Access Compliance Report

Public Rights-of-Way

(Curb Ramps)

Intersection ID: 52790	Main Street: COLEMON_KERRY_DR	Cross Street: FRIENDSHIP_VILLAGE_PL	Location: SE
ADA ID: E7AFCB4621A8	Ramp Type: Perp	Initial Pass/Fail: Fail	Overall Compliance: No
Severity Score: 22.5			
Codes/Mitigation Info/Possible Solution		Field Measurements/Component Compliance

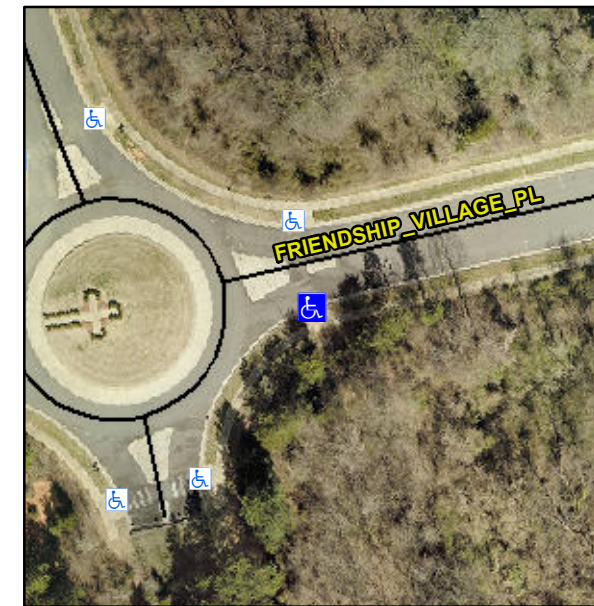
R304.5.1, R304.2.2, R304.5.3

Compliance	Description	Data	Compliance	Description	Data
N/A	Ramp Length (in)	71.0	No	Ramp Slope (%)	11.5
No	Ramp Width (in)	45.0	No	Ramp XSlope (%)	3.6
N/A	Flare Type LT	N/A	N/A	Flare Type RT	N/A
N/A	Flare Slope LT (%)	N/A	N/A	Flare Slope RT (%)	N/A
N/A	Flare Traversable LT?	N/A	N/A	Flare Traversable RT?	N/A
N/A	Landing Length (in)	N/A	N/A	DWS Provided?	N/A
N/A	Landing Width (in)	N/A	N/A	DWS Contrast?	N/A
N/A	Landing Slope (%)	N/A	N/A	DWS Length (in)	N/A
N/A	Landing X Slope (%)	N/A	N/A	DWS Full Width?	N/A
N/A	Landing Curb? (Y/N)	N/A	N/A	DWS Offset (in)	N/A
N/A	Shared Landing?	N/A			
N/A	Gutter Ponding?	N/A	N/A	Gutter Slope (%)	N/A
N/A	Gutter Lip Ht (in)	N/A	N/A	Gutter X Slope (%)	N/A
N/A	Painted X Walk1?	No	N/A	Painted X Walk2?	N/A
	X Walk 1 Direction	To N		X Walk 2 Direction	N/A
N/A	X Walk 1 Width (in)	N/A	N/A	X Walk 2 Width (in)	N/A
	X Walk 1 Slope (%)	3.6		X Walk 2 Slope (%)	N/A
	X Walk 1 X Slope (%)	3.1		X Walk 2 X Slope (%)	N/A

Remove & Replace Entire Ramp.
